WATER QUALITY MEMORANDUM

Utah Coal Regulatory Program

RE: Fourth Quarter 2015 Water Monitoring, PacifiCorp, Deer Creek Mine.
C/015/0018, Task ID #5037

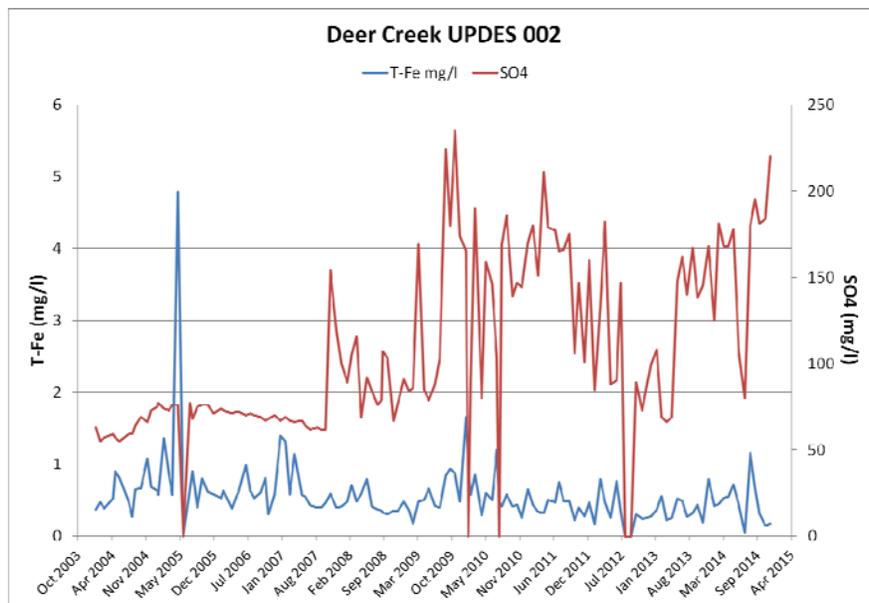
Mine water discharge at the UPDES outfall has ceased. The south half of the Deer Creek mine has been sealed. The pumps in the Mill Fork lease that produced the vast majority of in-mine dewatering were shut off as of mid-2015. Mine pools are developing and mine water will eventually gravity drain to the Deer Creek portals and the Rilda Right portals. Since there is no discharge from the Deer Creek mine portals the graph below is currently not applicable. Once gravity drainage reaches the Deer Creek and Rilda Right portals this graph should be reinitiated.

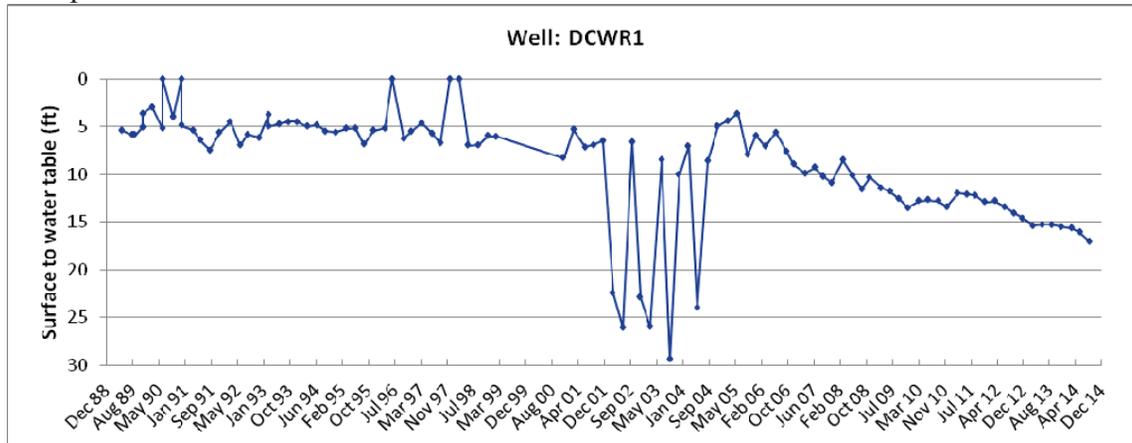
The Deer Creek Waste Rock well has been dropping since 2006 (following a small rise in

2004-2005). These changes are probably from factors other than disposal of waste rock at this site: a similar drop in water level is seen at WCWR1 at the Cottonwood/Wilberg Mine Waste Rock Disposal Site.

This well is no longer a Pacificorp water monitored site. It is now monitored by Bowie as the Deer Creek Waste Rock site.
